### **SERVICE BULLETIN**

SERVICE BULLETIN NO: 32-003 REF NO: 58

### LANDING GEAR - MAIN GEAR AND DOORS REPLACEMENT OF THE MAIN-GEAR SUPPORT STRUT

Support Strut Removal/Installation Figure 1

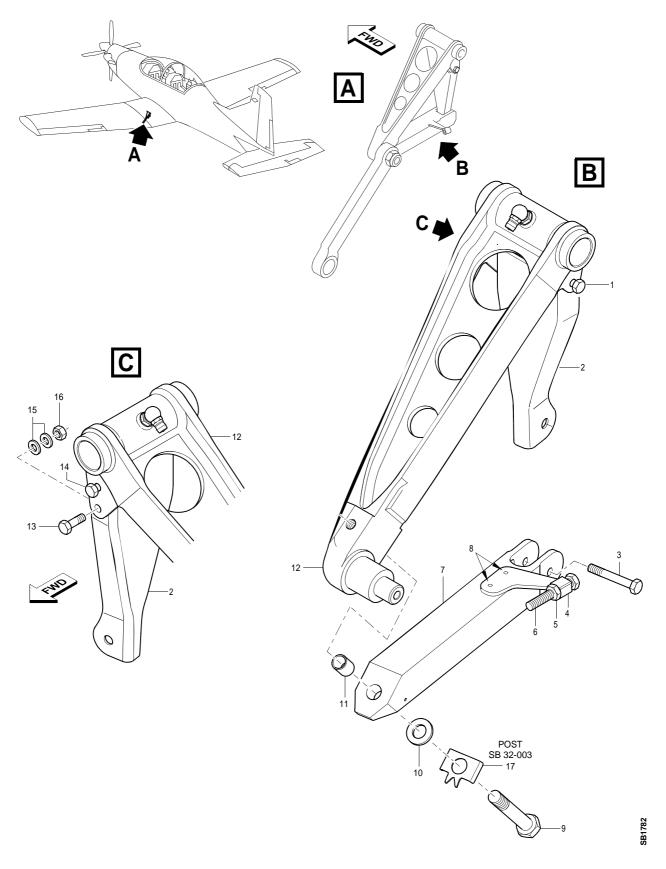
Cracks have occurred in the main-gear support struts on some aircraft. All the main-gear support struts that had cracks were made from material AA2024-T351. This material has a lower resistance to stress corrosion cracking.

The cause of the cracks is stress corrosion.

Replace the main-gear support strut with a new item made from the material with an increased resistance to stress corrosion cracking.

- (1) Remove and discard the lockwire from the bolt (9).
- (2) Remove and discard the bolt (9), the washer (10) and the bush (11) that attach the maingear support strut (7) to the upper folding strut (12).
- (3) Loosen, but do not remove, the bolts (1) and (14).
- (4) Remove the nut (16), the washers (15) and the bolt (13).
- (5) Move the folding strut lever (2) away from the main-gear support strut (7).

- (6) Remove the main-gear support strut (7). If the main-gear support strut (7) is difficult to remove, apply heat to the area.
- (7) Use the applicable size drill and remove the two rivets (8) that attach the support assembly (4) to the main-gear support strut (7). Keep the support assembly (4).
- (8) Discard the main-gear support strut (7).

- (1) Attach the support assembly (4) to the main-gear support strut (7) (P/N 532.10.09.128):
  - (a) Use a 4.1 mm (0.16 in.) diameter drill to make one of the rivet holes in the maingear support strut (7) (P/N 532.10.09.128).
  - (b) Temporarily attach the support assembly (4) to the main-gear support strut (7) (P/N 532.10.09.128) with a gripper pin.

- (d) Temporarily install, but do not fully tighten, the bolt (9) (P/N 932.35.14.227), the lock washer (17) (P/N 532.10.09.133) and the washer (10) (P/N 938.75.11.311) to attach the main-gear support strut (7) (P/N 532.10.09.128) to the upper folding strut (12).

Make the Holes in the Main-Gear Support Strut the Correct Size Figure 2

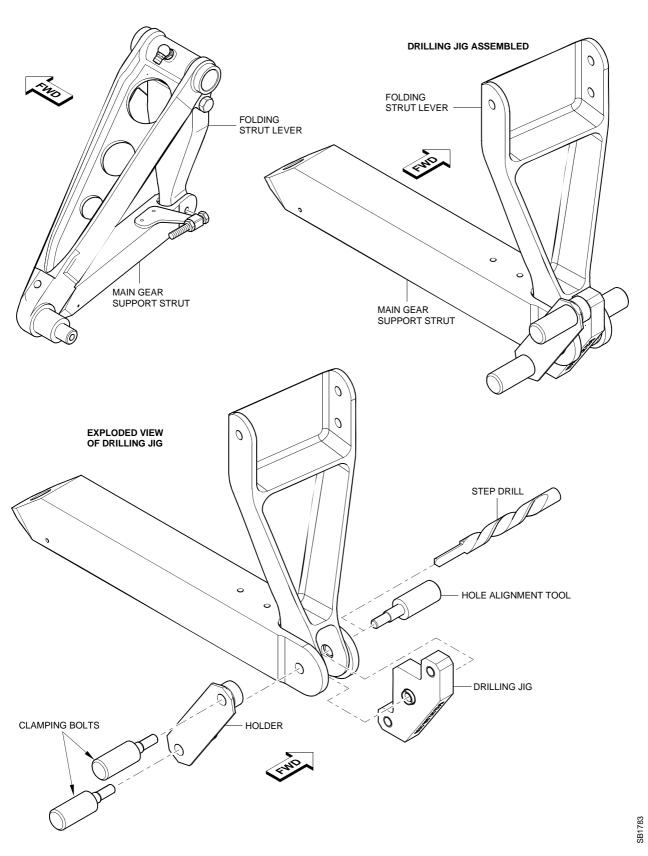
- (e) Engage the folding strut lever (2) in the main-gear support strut (7).
- (f) Make the Holes in the Main-Gear Support Strut the Correct Size (Ref. Figs. 1 and 2)

- Put the drilling jig (P/N 513.32.09.119) into one of the holes in the folding strut lever (2). Make sure the step on the drilling jig (P/N 513.32.09.119) engages in the hole of the folding strut lever (2).

- <u>3</u> Use the hole alignment tool (P/N 513.32.09.124) to align the holes in the folding strut lever (2) and the main-gear support strut (7) (P/N 532.10.09.128).

- Tighten the bolts (1) and (14)
    - Tighten the two clamping bolts (P/N 513.32.09.123)
    - Tighten the bolt (9).
  - 5 Use the step drill (P/N 513.32.09.122) to increase the diameter of the other hole in the main-gear support strut (7) (P/N 532.10.09.128) to 7.6 mm.

- Put the holder (P/N 513.32.09.120) in position on the drilling jig (P/N 513.32.09.119) and install the two clamping bolts (P/N 513.32.09.123).
  - <u>8</u> Use the step drill (P/N 513.32.09.122) to increase the diameter of the other hole in the main-gear support strut (P/N 532.10.09.128) to 7.6 mm.

- 9 Remove the two clamping bolts (P/N 513.32.09.123), the holder (P/N 513.32.09.120) and the drilling jig (P/N 513.32.09.119).
- 10 Remove the bolt (9), the lock washer (17) and the washer (10).
- 11 Loosen, but do not remove, the bolts (1) and (14).
- 12 Remove the nut (16), the washers (15) and the bolt (13). Discard the nut (16).
- 13 Move the folding strut lever (2) away from the main-gear support strut (7).
- 14 Remove the main-gear support strut (7) (P/N 532.10.09.128).
- Use the reamer (P/N 901.80.02.030) and increase the diameter of the holes in the main-gear support strut (7) (P/N 532.10.09.128) to 7.938 + 0.015
   0.0 mm (0.3125 + 0.0006 0.0 in.).
